KENWOOD

SERVICE BULLETIN

TS-930S 15 METER INTERNAL BEAT TONE

DATE 1-27-84

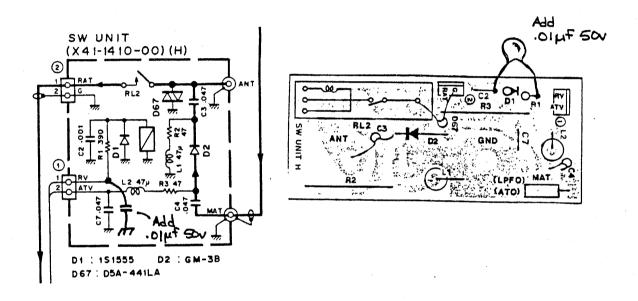
Some users have reported an internal beat tone that appears every 10 Khz, when operating in the range of 20-21.5 Mhz. Apparently the RV terminal of Switch Unit H is being affected by the 1st loop of the PLL unit. The cure is relatively simple. Add a .01 uf 50v disc ceramic capacitor on the RV line of Switch Unit H as shown below.
